SERVICE BULLETIN

M-1026

SAFETY RECALL CODE 079 FRONT FORK BRACKET PINCH SCREWS AND WINDSHIELD MOUNTING HARDWARE

Figure 1. Original Front Fork Bracket Pinch Screws
-- Right Side

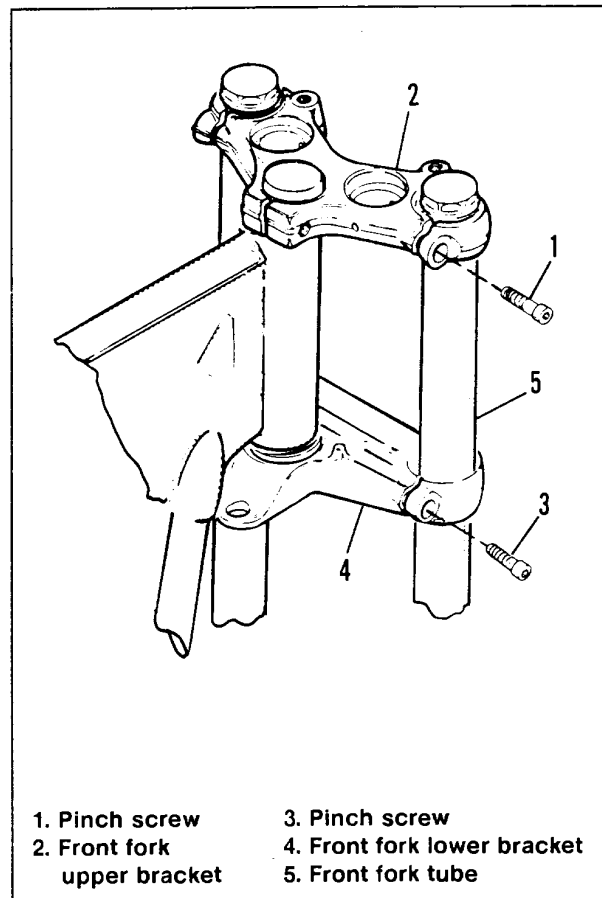
1. See Figure 1. Remove original hex socket head pinch screw (1) from right side of front fork upper bracket (2).
 - If original screw is 1-1/2 in. long, replace with new 1-1/2 in. long button head TORX screw from kit. Tighten new pinch screw to 30 - 35 ft-lbs torque.
 - If original screw is 2-1/4 in. long (this longer screw is used when attaching a fork-bracket-mounted directional lamp), replace with new 2 in. long button head TORX screw from kit. Make sure directional lamp is aimed directly forward. Tighten new pinch screw to 30 - 35 ft-lbs torque.

2. Repeat Step 1 for original hex socket head pinch screw (3) on right side of front fork lower bracket (4).
3. Repeat Steps 1 and 2 for left side of vehicle.

Figure 3. FXRP-Windshield -- New Windshield Mounting Hardware and Front Fork Pinch Screws -- Right Side

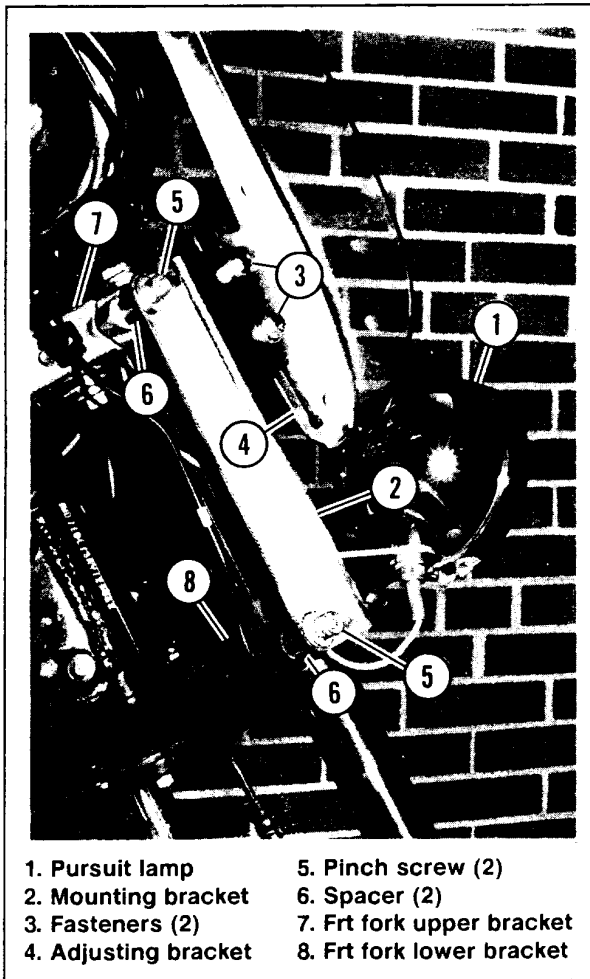
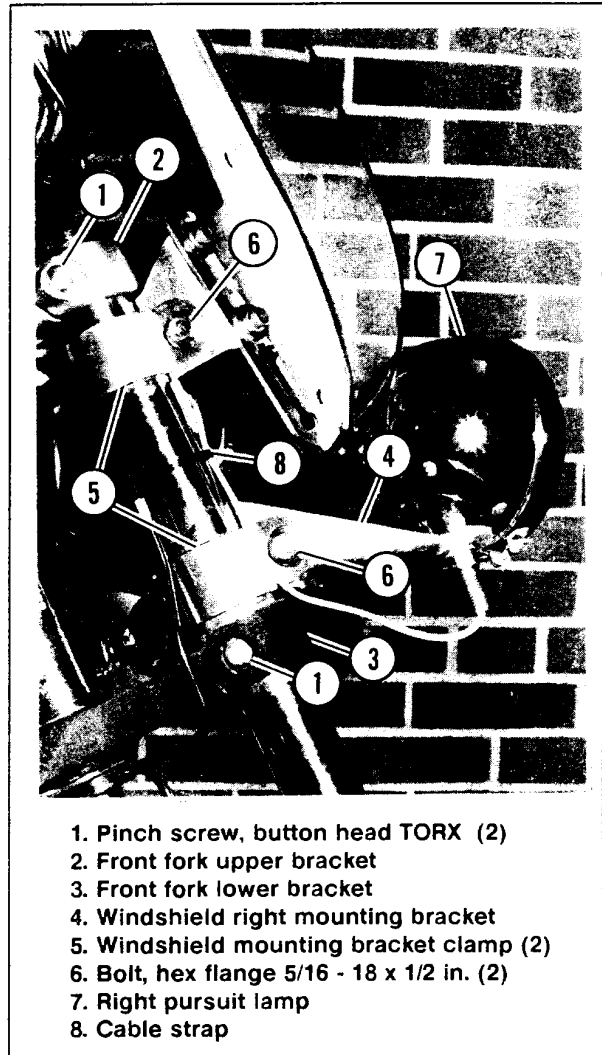
4. See Figure 2. Remove right pursuit lamp (1) from original windshield right mounting bracket (2); save fasteners.

5. Remove fasteners (3) which attach original windshield right mounting bracket to windshield right adjusting bracket (4); discard fasteners.
6. Remove original hex socket head pinch screw (5), washer, and spacer (6) from right side of front fork upper bracket (7); discard screw, washer, and spacer.

7. Loosen original hex socket head pinch screw (5) on right side of front fork lower bracket (8) only enough to allow you to pivot the original windshield right mounting bracket (2) forward somewhat. Pivot the mounting bracket (2) forward to expose open pinch screw hole in right side of front fork upper bracket (7).
8. See Figure 3. Install new 1-1/2 in. long button head TORX screw (1) from kit into pinch screw hole in right side of front fork upper bracket (2). Verify that proper right front fork tube extension exists above front fork upper bracket (must be identical to left front fork tube extension). Tighten new pinch screw to 30 - 35 ft-lbs torque.

9. See Figure 2. Remove original hex socket head pinch screw (5), washer, original windshield right mounting bracket (2), and spacer (6) from front fork lower bracket (8); discard screw, washer, mounting bracket, and spacer.
10. See Figure 3. Install new 1-1/2 in. long button head TORX screw (1) from kit into pinch screw hole in right side of front fork lower bracket (3). Tighten new pinch screw to 30 - 35 ft-lbs torque.
11. Loosely install new windshield right mounting bracket (4) from kit to right front fork tube using two new windshield mounting bracket clamps (5) and 5/16 - 18 x 1/2 in. hex flange bolts (6) from kit.
12. See Figure 4. Position original windshield right adjusting bracket (1) (part of windshield assembly) over outboard side of new windshield right mounting bracket (2) (attached to right front fork tube).

Figure 4. FXRP-Windshield -- New Windshield Mounting Hardware -- Right Side

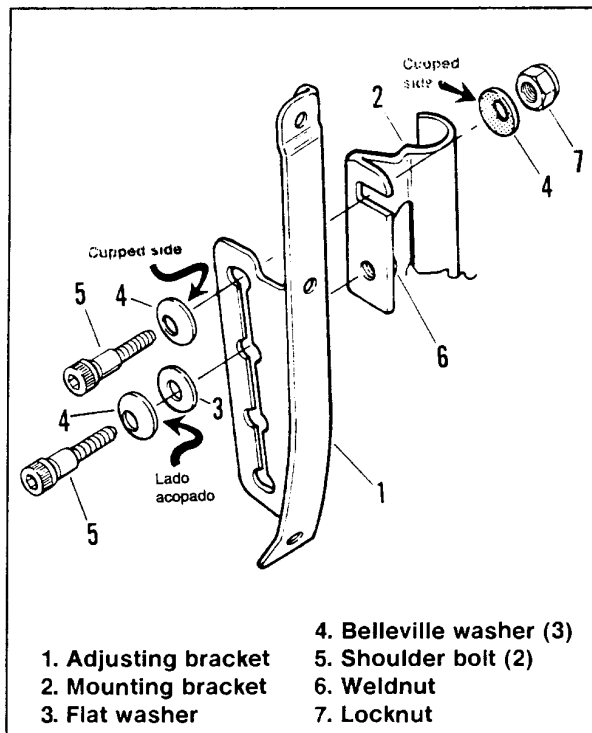
Do not substitute any ordinary fasteners in place of the special shoulder bolts (5) (H-D Part No. 52255-93) and Belleville washers (4) (H-D Part No. 6068) included with this windshield assembly. These bolts and washers are designed to maintain a specific clamping force in this windshield mounting application.

13. Insert a shoulder bolt (5) from kit through one Belleville washer (4) from kit (with concave (cupped) side of washer facing away from bolt head), through flat washer (3) from kit, through slot of adjusting bracket (1), and into threaded weldnut (6) of mounting bracket (2). Do not final tighten at this time.

See Figure 4. Before tightening windshield mounting shoulder bolts (5), make sure of the following:

- The Belleville washer (4), the flat washer (3), and the adjusting bracket (1) are positioned over the unthreaded, larger O.D. shaft section of the lower shoulder bolt (5); and the shoulder surface of the lower shoulder bolt (5) contacts the weldnut (6) of the mounting bracket (2).
- The first Belleville washer (4), the adjusting bracket (1), the mounting bracket (2), and the second Belleville washer (4) are positioned over the unthreaded, larger O.D. shaft section of the upper shoulder bolt (5); and the shoulder surface of the upper shoulder bolt (5) contacts the locknut (7).

16. See Figure 4. Tighten both shoulder bolts (5) to 8 - 10 ft-lbs torque.
17. See Figure 3. Install right pursuit lamp (7) onto new windshield right mounting bracket (4) using original fasteners. Aim pursuit lamp directly forward, and tighten fasteners securely.
18. Route pursuit lamp wiring as shown in Figure 3. Install wire terminal(s) in appropriate pursuit lamp pin connector(s). Secure wire to right front fork tube using a cable strap (8).
19. Repeat Steps 3 - 18 for left side of vehicle.
20. Connect pursuit lamp wiring at pin connector(s). Lower vehicle from center stand. Test pursuit lamps.

Figure 5. FXRS-Convertible Windshield -- Right Side

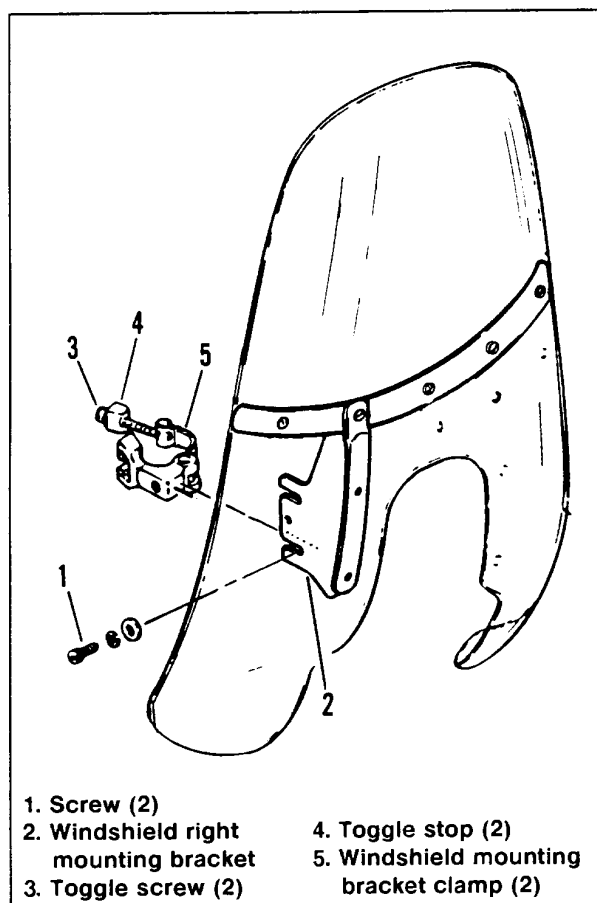
- Repeat Step 1 for original hex socket head pinch screw (3) on right side of front fork lower bracket (4).
- See Figure 5. Remove both original socket head screws (1) with washers from windshield right mounting bracket (2); discard fasteners. Lift windshield/mounting bracket assembly away from both windshield mounting bracket clamps (5) on right front fork tube.

- With masking tape or a grease pencil, mark position of each original right side windshield mounting bracket clamp (5) on right front fork tube. Loosen socket head toggle screw (3) of each right side clamp (5) enough to slide toggle stop (4) out of slot in clamp. Remove and discard both original clamps.

- Install two new windshield mounting bracket clamps (5) from kit in same positions as original clamps on right front fork tube; use hex key included with kit to loosely secure new round head toggle screw (3) on each clamp.

- Position windshield right mounting bracket (2) (part of windshield assembly) over new clamps (5) on right front fork tube. Verify windshield alignment, then secure with two new round head screws (1) and washers using hex key from kit
